U.S. NUCLEAR REGULATORY COMMISSION

STANDARD REVIEW PLAN

9.2.5 ULTIMATE HEAT SINK

DRAFT Rev. 3 - April 1996

3. Figures 1, 2, and 3⁶³ give the residual decay heat release in terms of fractions of full reactor operating power based on a reasonably realistic reactor operating time of 16,000 hours.

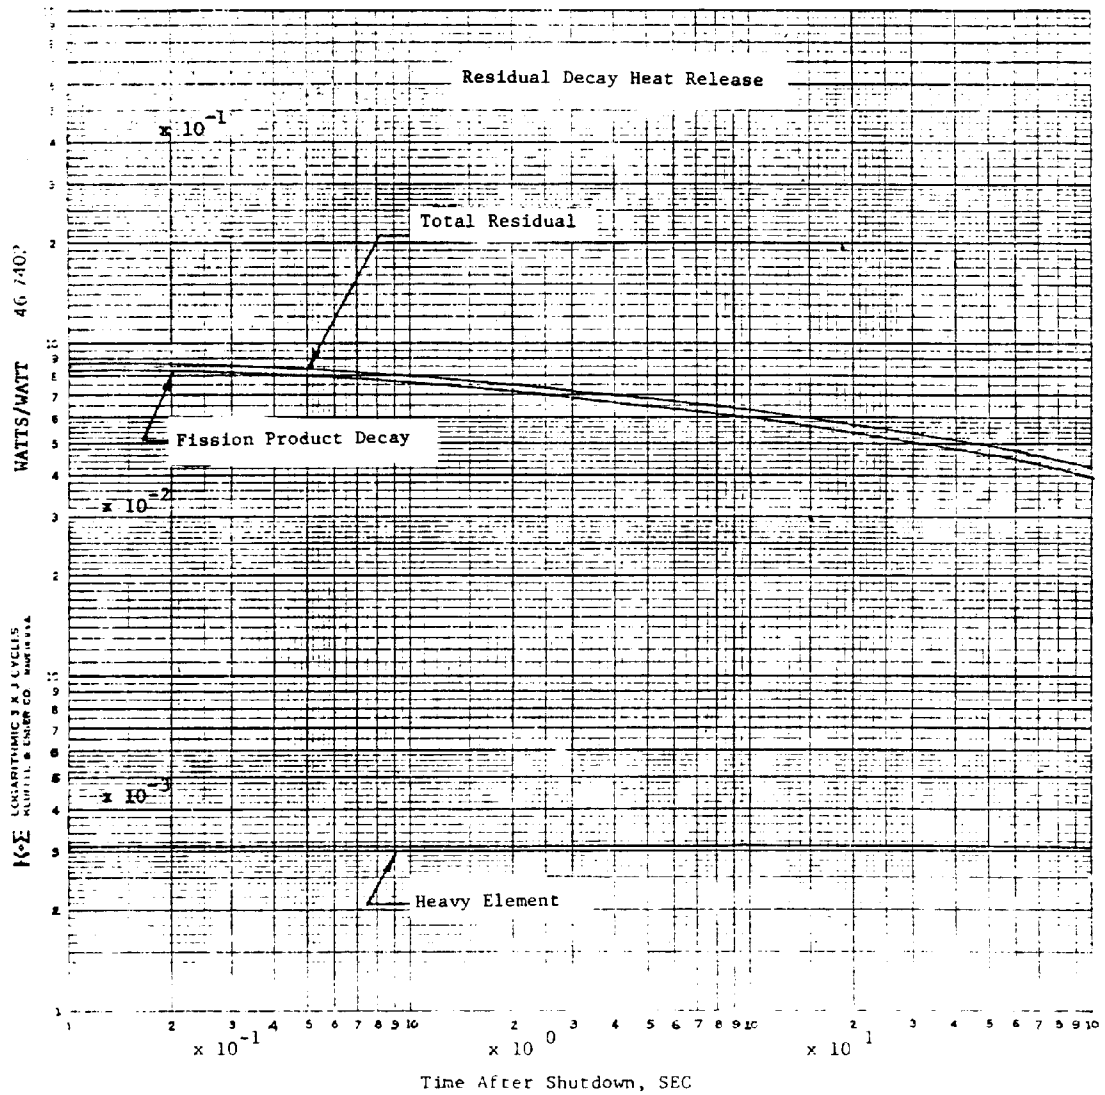
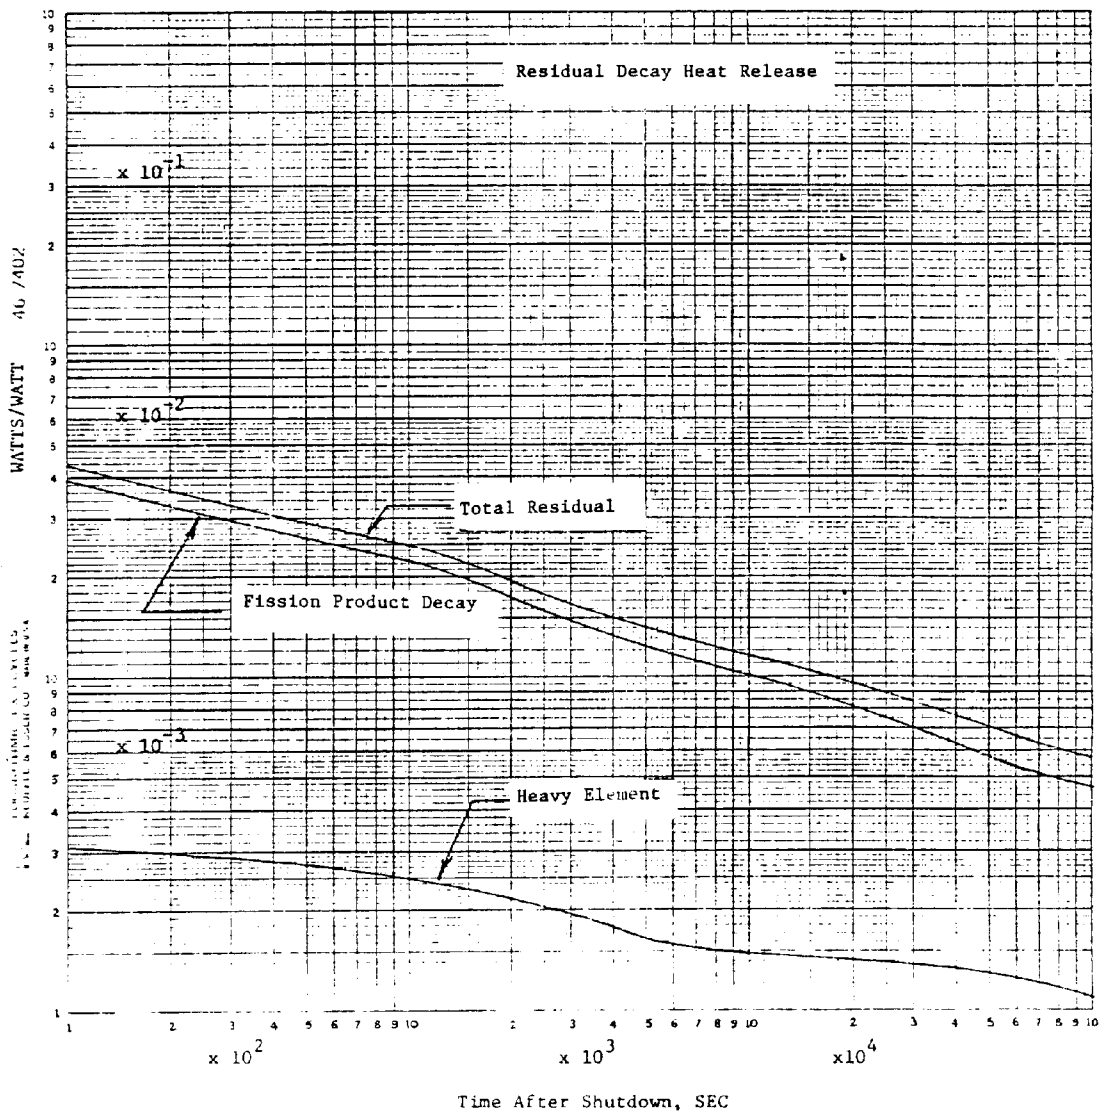
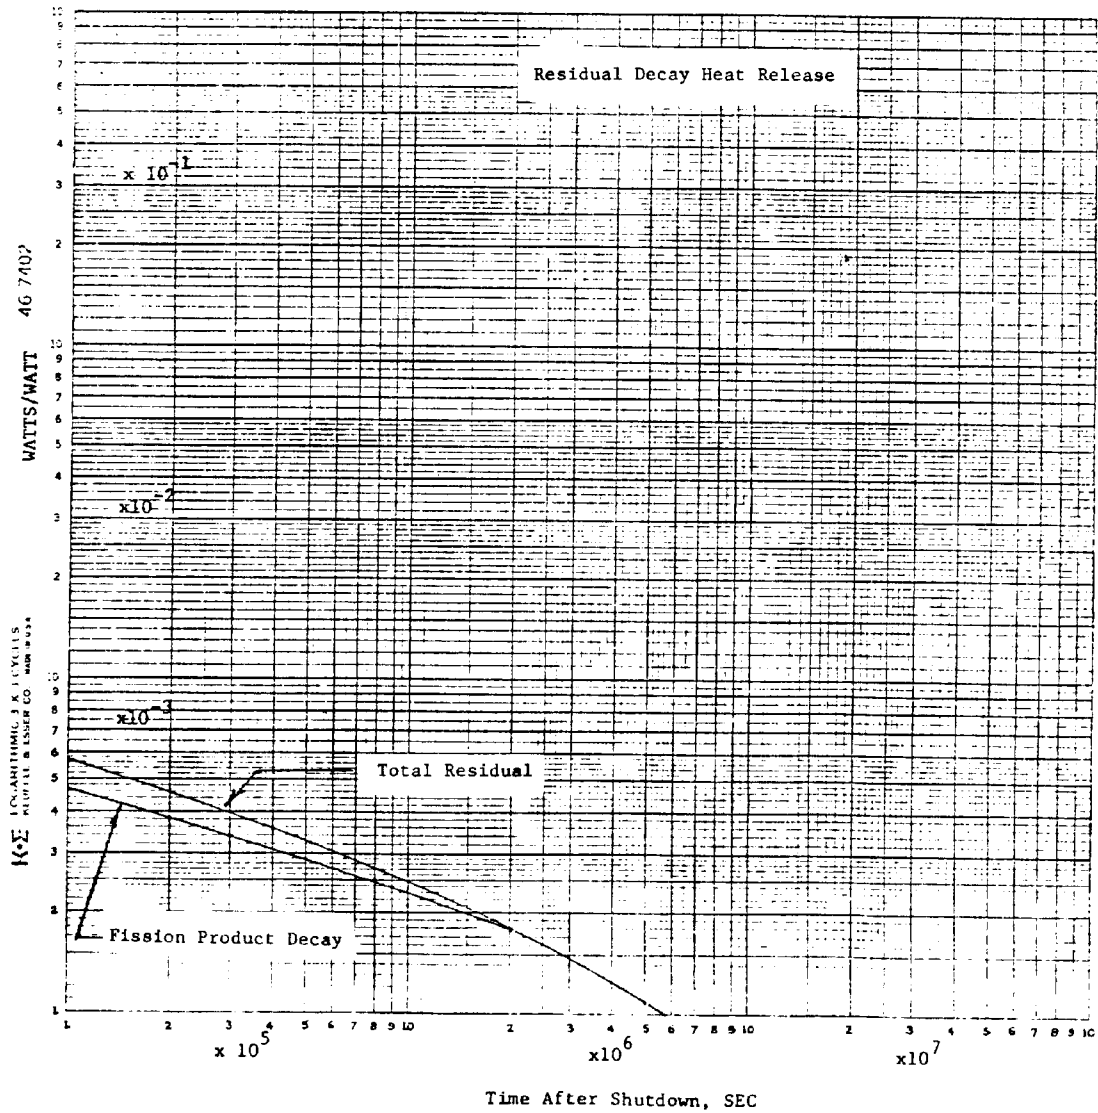
63.	SRP-UDP format item	In-text callouts are provided for Figures 1, 2, and 3. None of the three figures are labeled, however, and all three should be revised to maximize the benefit they provide to reviewers.
